Meghna Knit Composite Ltd (Extension)

Gilarchala, Sreepur, Gazipur
(24.186253N, 90.425741E)

28 November 2023

2. Observations

Observation-7: Mismatches in as-built drawings. (Store Building).

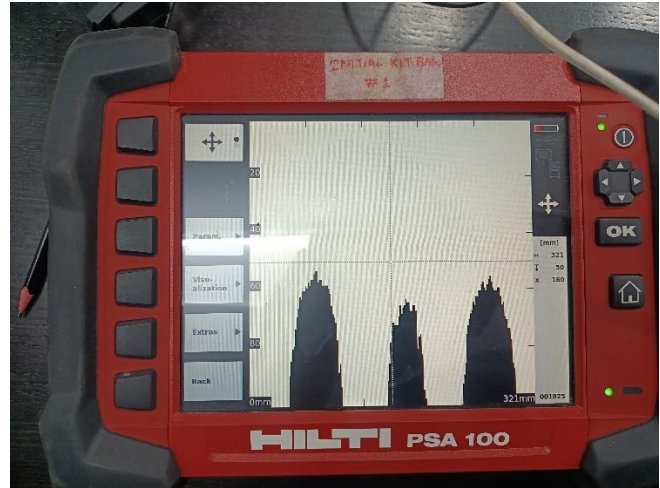
Description: Amount of rebar in C-3 Type column at first floor was found 10 nos instead of 12 nos. Building engineer is required to update the as-built drawings as per on site condition and submit to RSC.

Observation-09: Non-structural elements not anchored or braced. (Store Building).

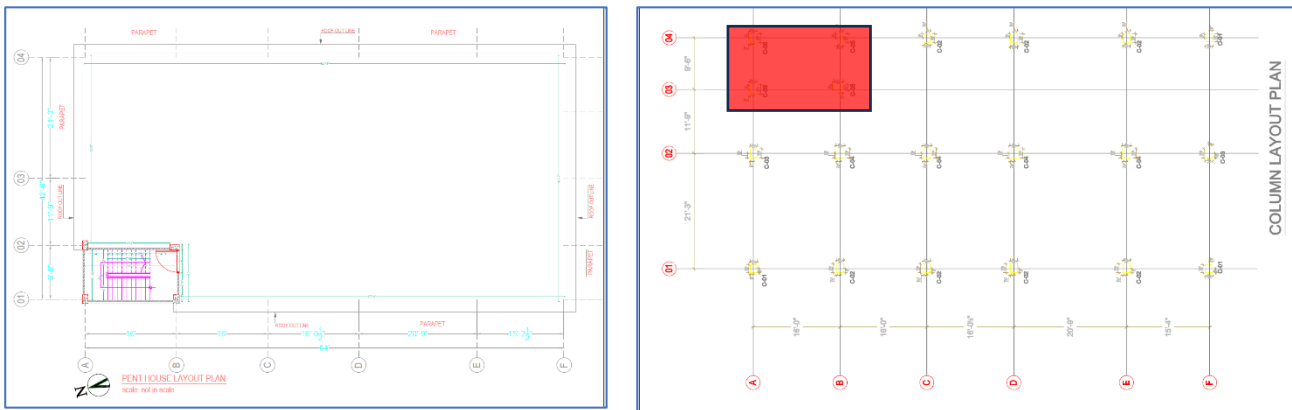
Description: Some racks on floors are not anchored or braced to resist lateral (earthquake) forces. The factory is required to anchor/brace all non-structural elements adequately to resist earthquake forces.

Observation-14: Incomplete lateral stability system. (New LK Dryer Shed).

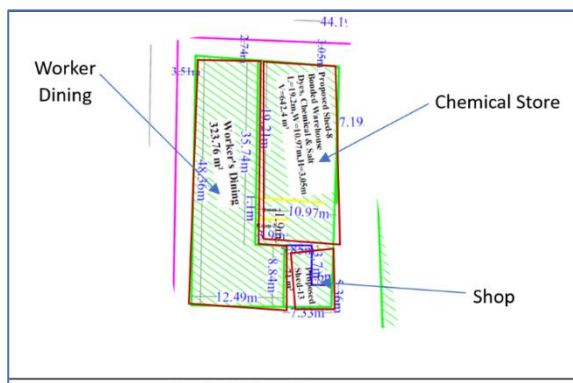
Description: Though compression struts were shown in the design report, no compression strut was found on-site along the long direction. Only cable bracings were found onsite. So, lateral stability in the long direction is incomplete. The building engineer is required to check the stability system of the existing structure.

Observation 17: Lack of lateral stability and connection adequacy. (Worker Dining).

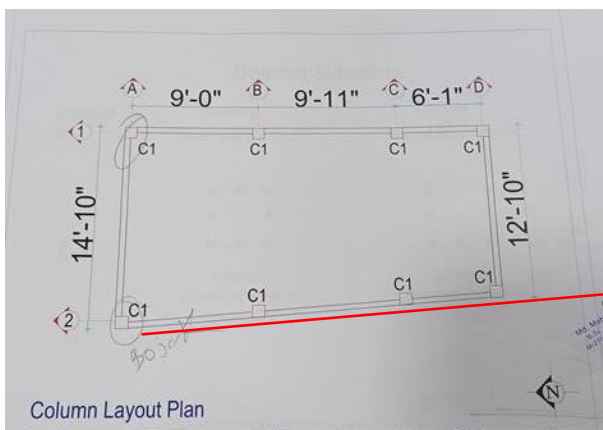
Description: Lateral load transfer media was not available along the long direction. Also, some connection was found to be apparently inadequate. The building engineer is required to check the lateral stability and connection adequacy of the shed.

Observation-19: Cracks under beam soffit. (RMS Room).

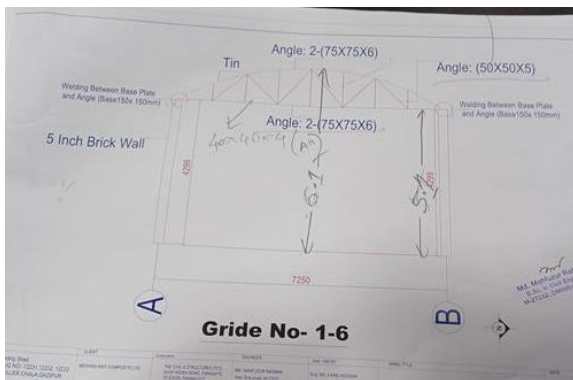
Description: Crack found under beam soffit at North side of cooling tower. Building engineer is required to investigate the extent of crack and repair with a suitable method.

Observation-21: lack of lateral stability. (Loading & Unloading Shed).

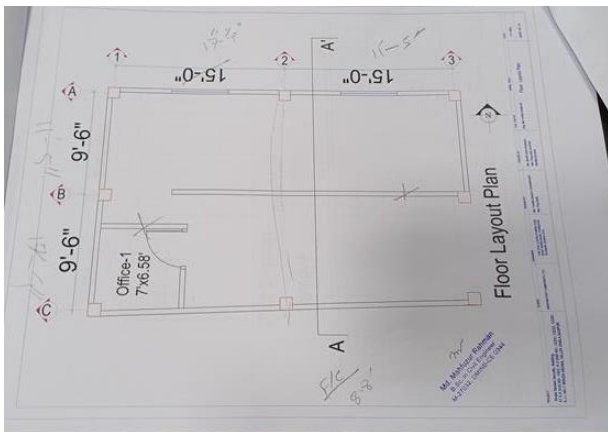
Description: Lateral load transfer media was not available along the long direction. The building engineer is required to check the lateral stability and connection adequacy of the shed.

Observation-22: Lack of as-built drawings. (Security Building).

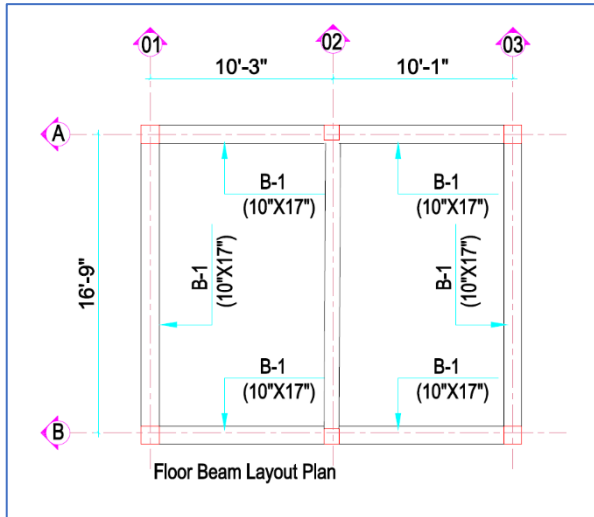
Description: As-built drawings were not found for the Security Building. A set of drawings were available on site which was totally different from as-built condition. Building engineer is required to survey the full structure and prepare full set of as-built drawings as per on site condition and submit to RSC.

Observation-23: Discrepancies in as-built drawings. (Maintenance Room).

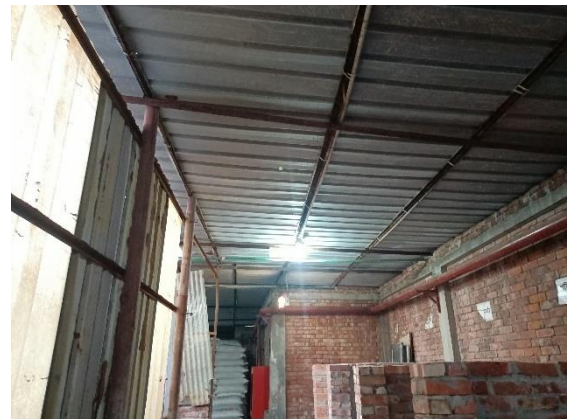
Description: Number of rebar in columns and beam layout did not match fully with as-built condition. Building engineer is required to update the as-built drawings as per on site condition and submit to RSC.
